PROJECT
RYLANDS BUILDING, MANCHESTER

TITLE
COMPARISON PLAN FIFTH FLOOR
- NON MATERIAL AMMENDMENT

JOB No	DWG No	REV
1526	AL[05]2218	*

ISSUE FOR
PLANNING DOCUMENT

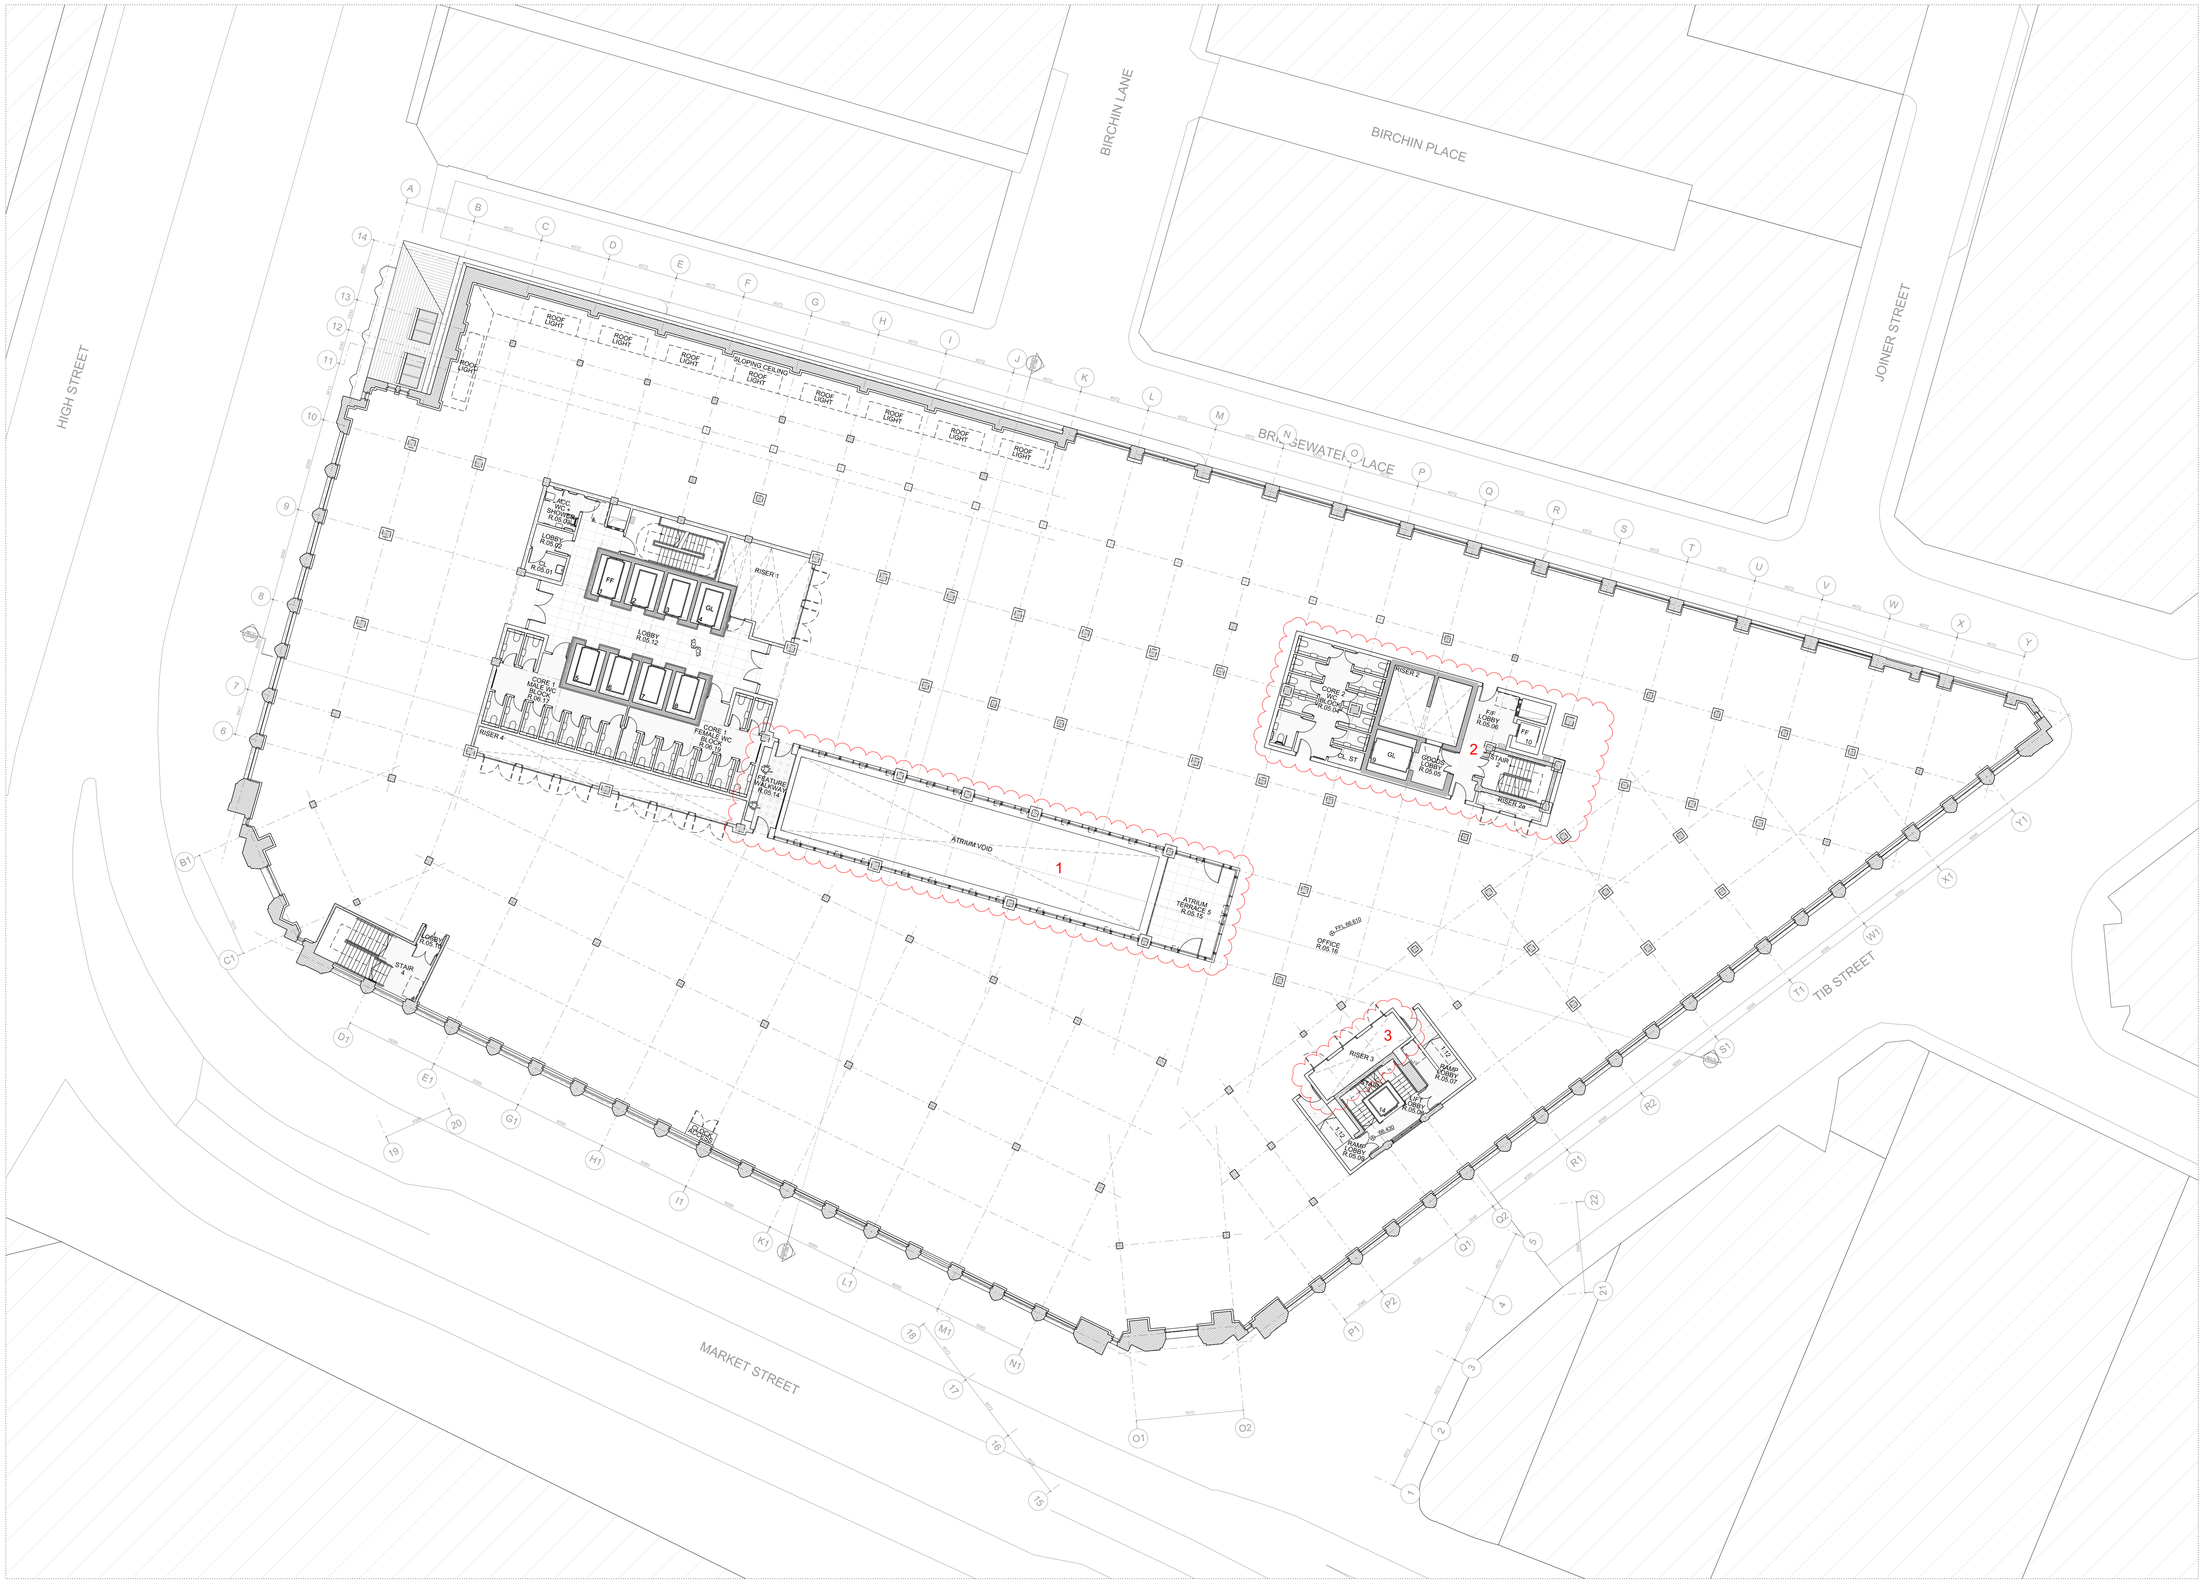
1. Atrium width reduced to decrease structural intervention and increase retention of historic structure.

2. Stair core 2 arrangement updated to reduce works to existing staircase and provide additional goods lift.

3. Service riser provided adjacent stair 3 to improve building functionality.
